Docket No. 034942-000245
(formerly 110619CFB.US)

In the Drawings

The attached replacement and annotated sheet(s) of drawings include changes to FIG. 1 and FIG. 2 as follows:

Serial No.: 09/885,811

Fig. 1

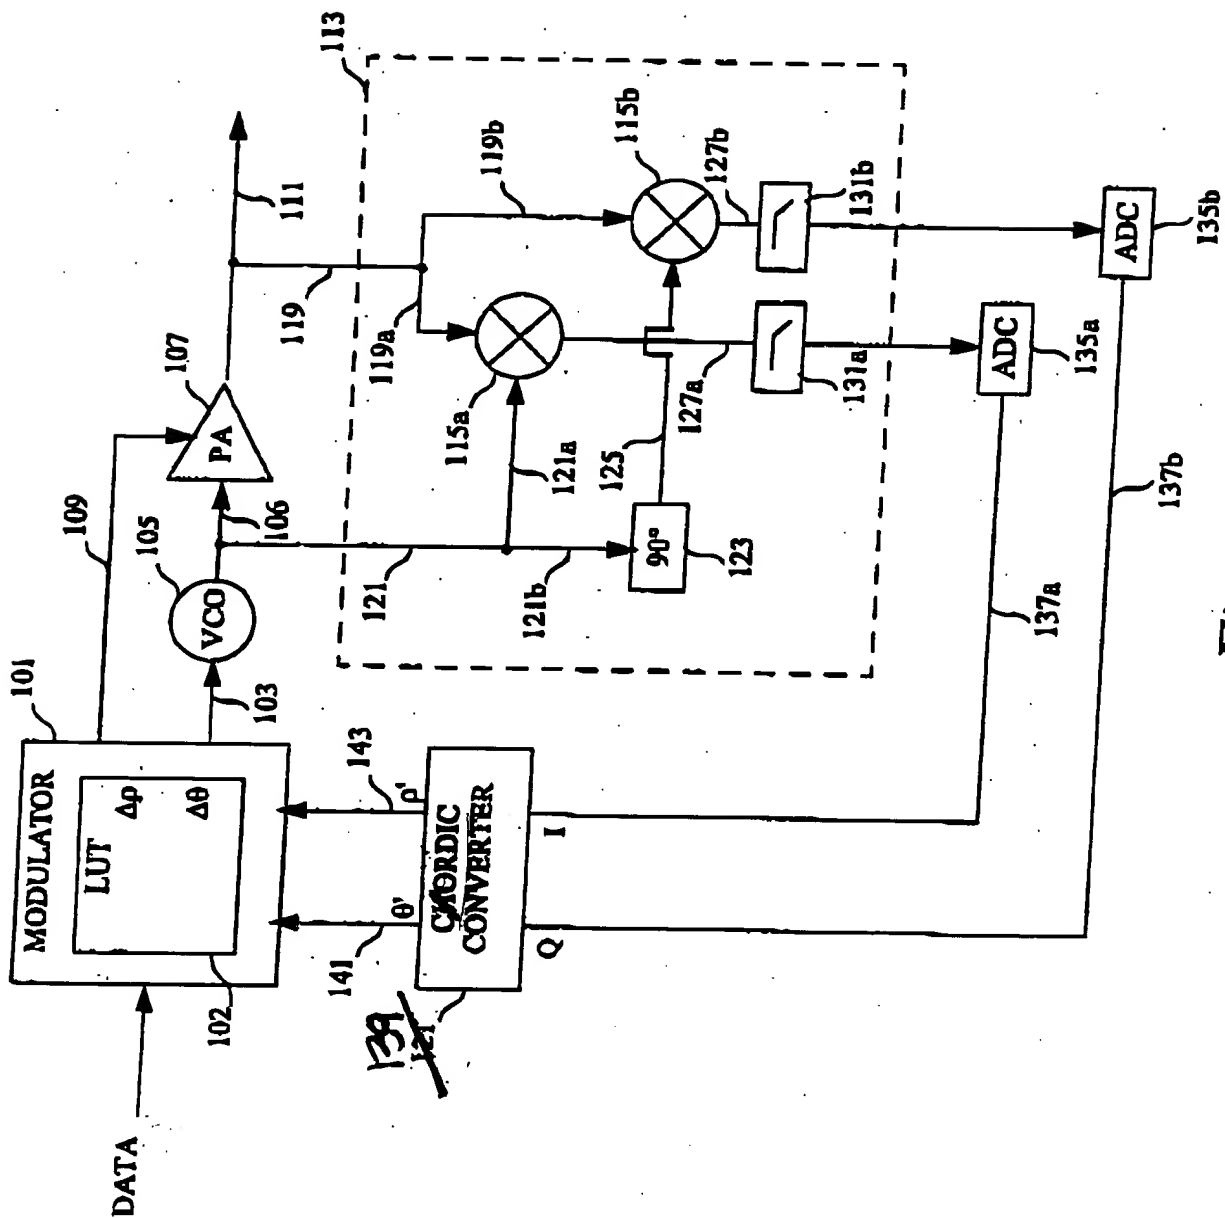
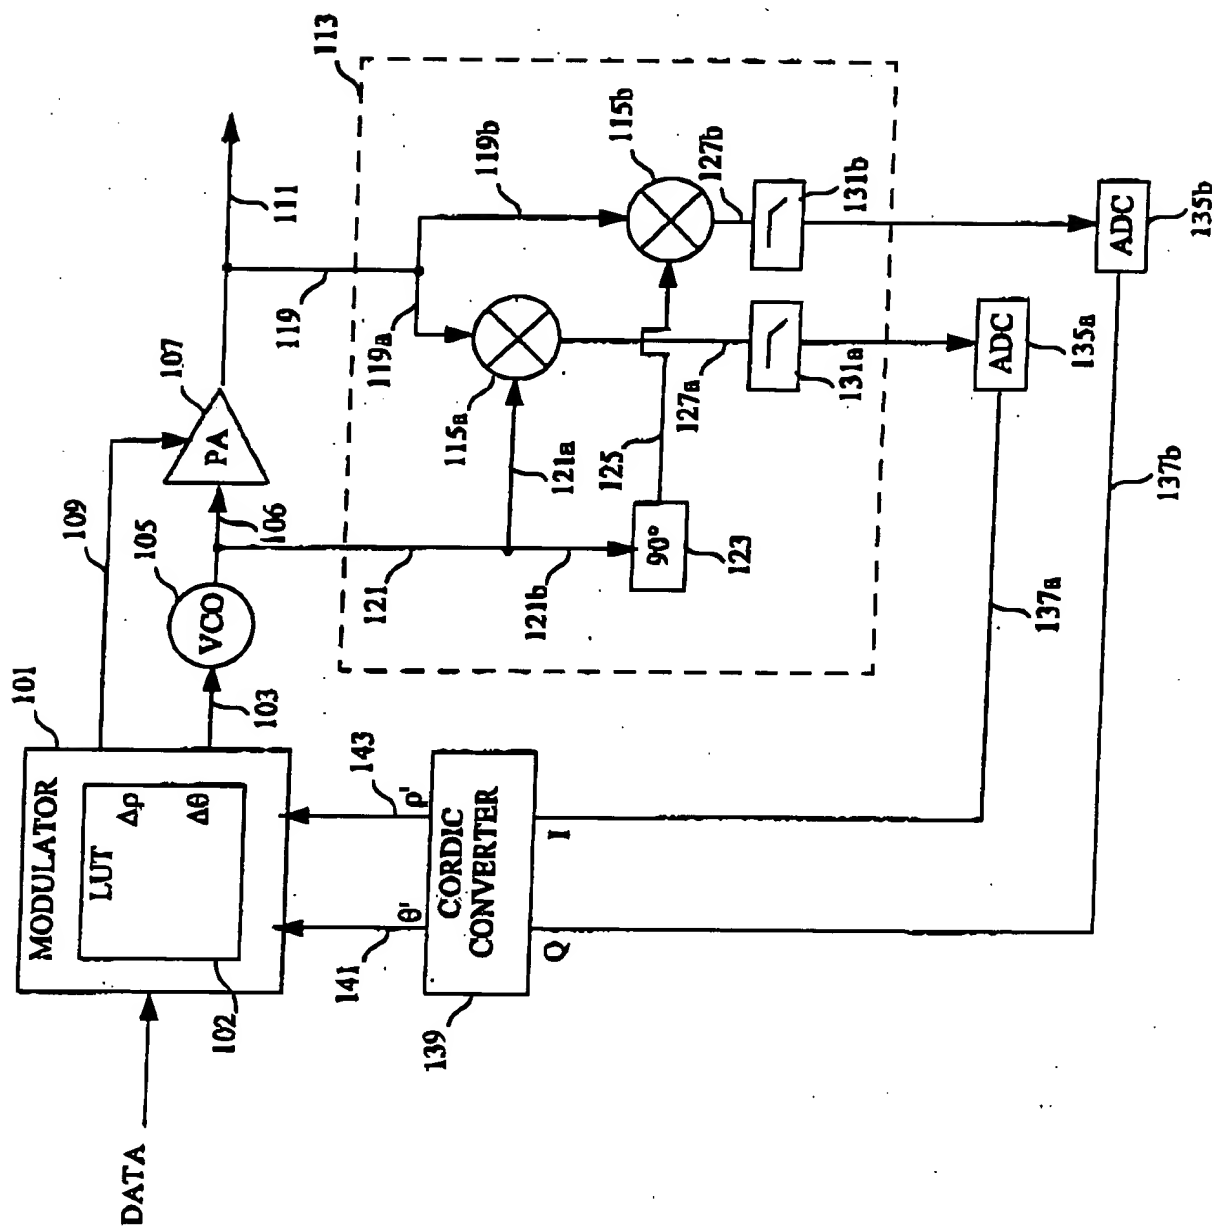
FIG. 1 has been amended such that box 121 has been relabeled 139 for consistency with the specification, and the descriptive legend has been changed from "chordic converter" to "cordic converter" to thereby correct the misspelling.

Fig. 2

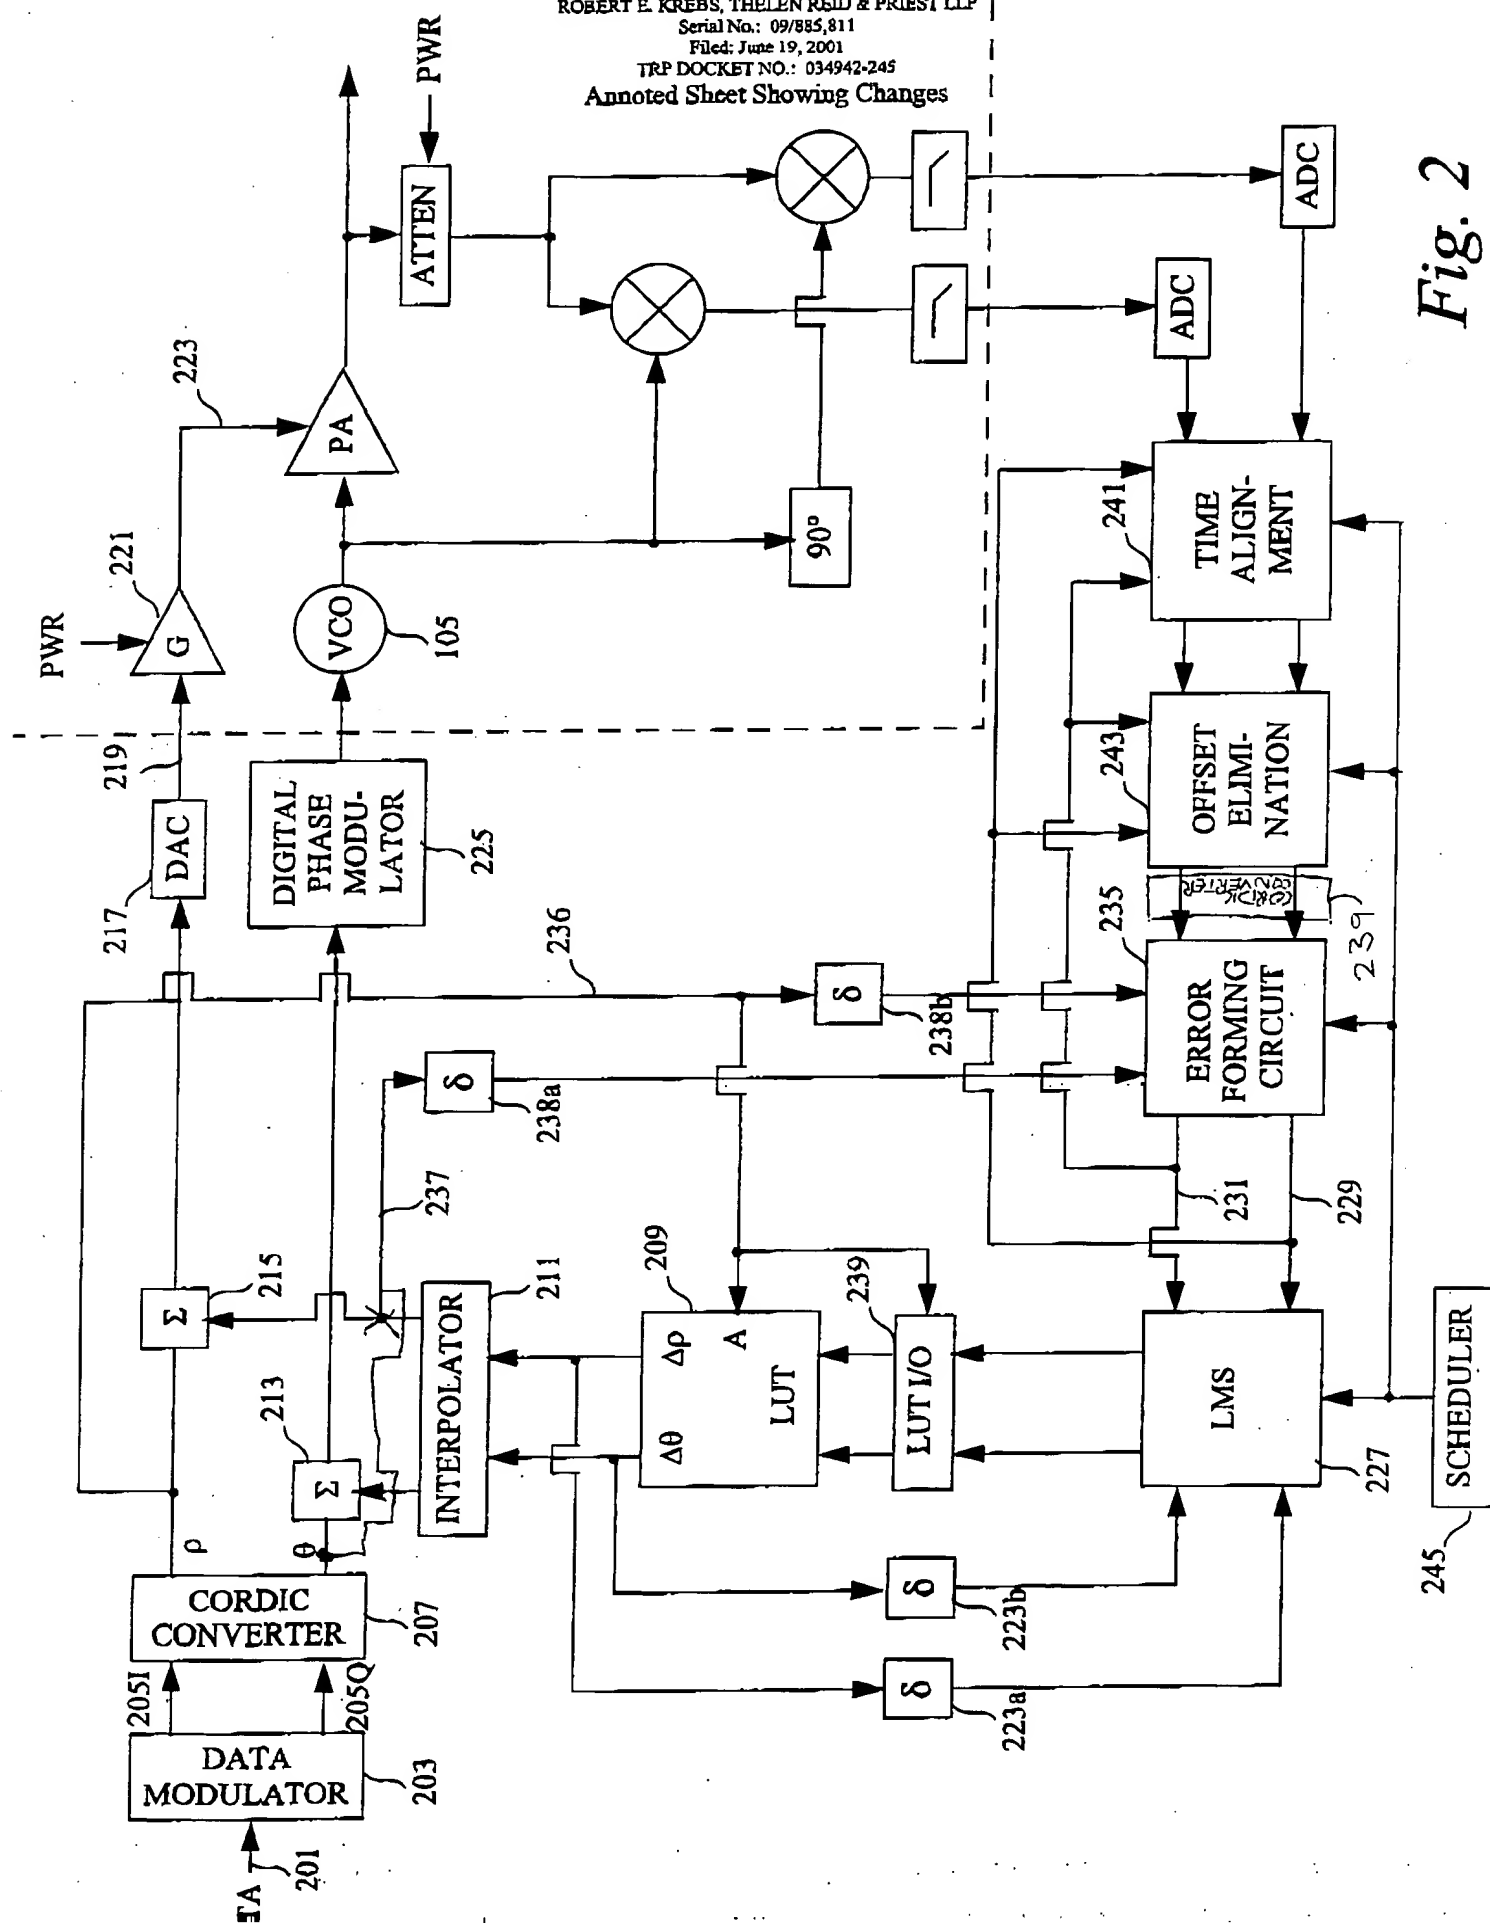
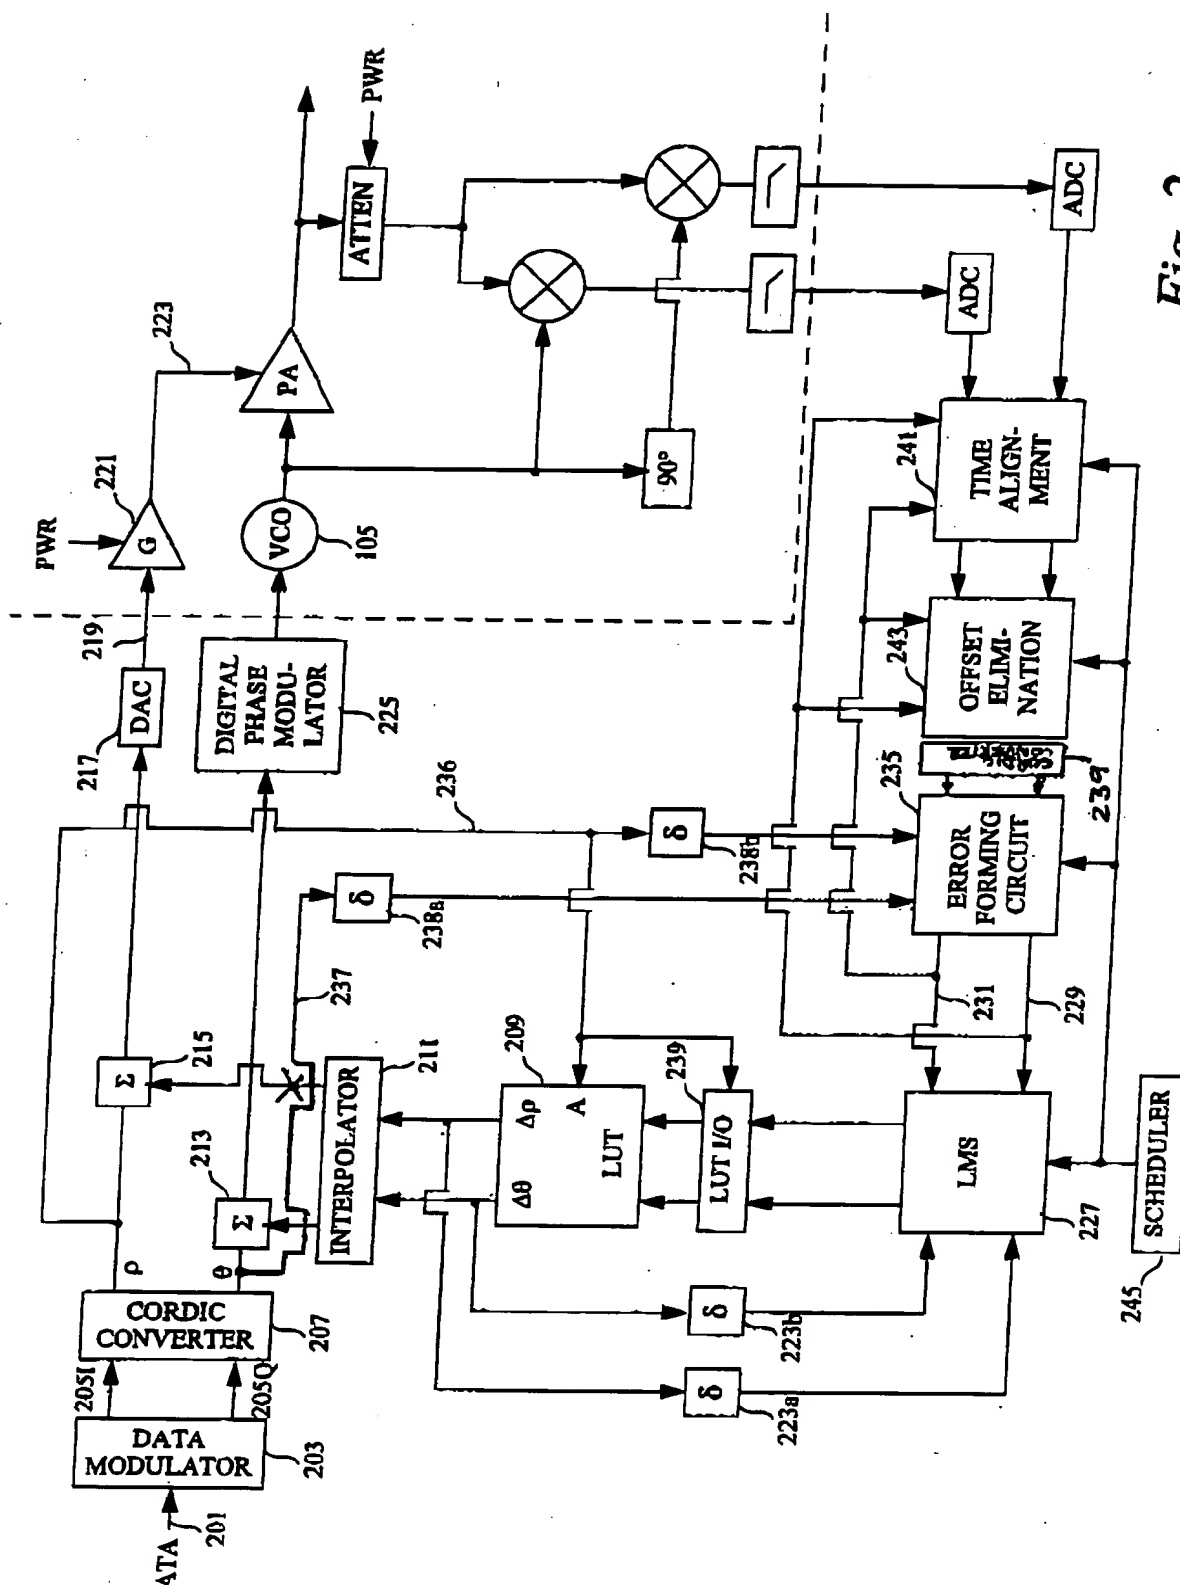
FIG. 2 has been amended to re-route the connection 237 to the delay element 238, and to insert cordic converter 139 of FIG. 1 in its proper place for consistency with FIG. 1 and the remainder of the description.
